KEYSTONE XL PIPELINE PROJECT

0528-SD-P4-578.6-579.4-S

KEYSTONE XL PROJECT
RV-0528-01 ROUTE REVISION

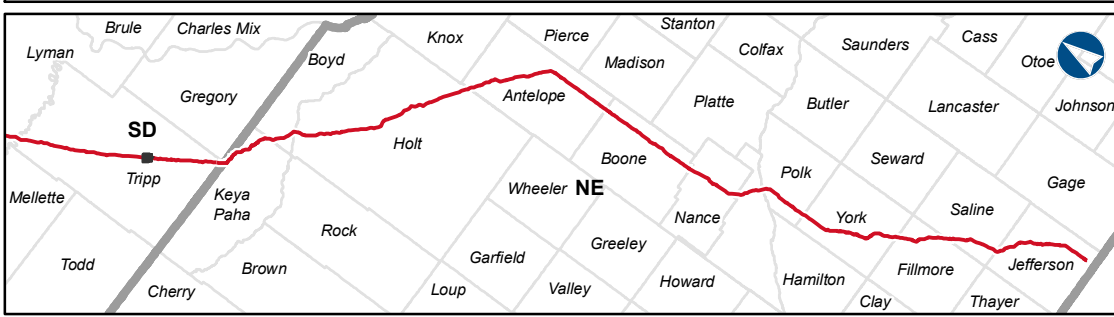
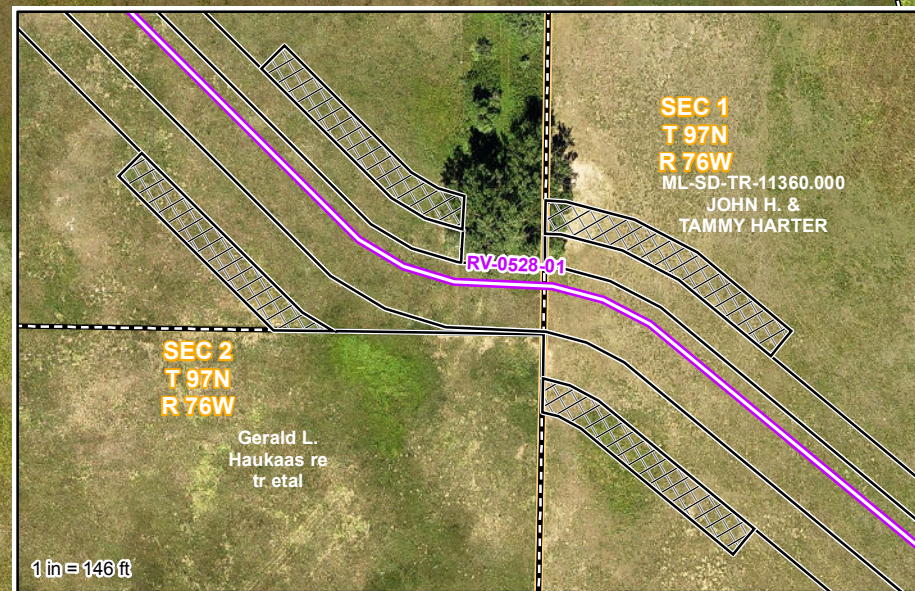
3	REASON FOR ROUTE VARIATION (Please include reason for route variation):		
	<p>The primary reason for this proposed change is to shift the CL out of a swampy low area near a pond which also puts centerline at ~176ft from Landowner's well. There will be a 50 ft neckdown to cross the shelterbelt with 200' x 25' new workspace added to all four (4) sides of the shelterbelt without impacting any new landowners. Landowner (ML-SD-TR-11360.000 - Harter) prefers this route as there will be no tree removal due to the 74' gap in the shelterbelt where the centerline crosses. Terrain and soil conditions are improved on proposed route.</p> <p>This centerline route variation is proposed by Land following discussions with landowner and has been field reviewed by civil survey.</p>		
	DETAIL ROUTE VARIATION (Please describe route variation in detail):		
	<p>The proposed route variation starts near MP 578.56 and continues for ~1,936 feet before deviating east at an angle of 42° for ~160 feet. The proposed reroute then angles 42° southeast for 511 feet before deviating an additional 10° for ~1,842 feet to tie back in with the current CL at MP 579.37. The neckdown will be along the ~160 ft section of the proposed centerline that crosses the shelterbelt from tract ML-SD-TR-11340.000 (O'Bryan) and ML-SD-TR-11360.000 (Harter). The Pls for this reroute have been broken down.</p> <p><u>2 Tracts Impacted:</u> ML-SD-TR-11340.000 - Richard M. O'Bryan & Mavis A. O'Bryan ML-SD-TR-11360.000 - John H. & Tammy Harter</p>

ADDITIONAL IMPACTS (Please include any additional impacts which may affect cost; crossings, induction bends, etc.):		
	<p>The proposed route variation extends outside the current environmental surveyed corridor and will require additional survey. The proposed reroute also avoids crossing a wetland area and tree removal, both saving costs. The cost savings for the wetland crossing are estimated below, but the cost savings for eliminating tree removal is currently unknown.</p>		
	Is there an increase/decrease in the number of crossings?	Yes <input checked="" type="checkbox"/> X	No <input type="checkbox"/>
	If yes, please list:	<input type="text" value="The reroute avoids crossing a wetland area."/>	
	COST ANALYSIS (costs incurred or saved from the route variation)		
	Additional length of route realignment	<input type="text" value="37"/> ft.	\$ <input type="text" value="13,183.20"/> \$ 360/ft
	Additional length of side-hill construction:	<input type="text" value="0"/> ft.	\$ <input type="text" value="-"/> \$ 19/ft
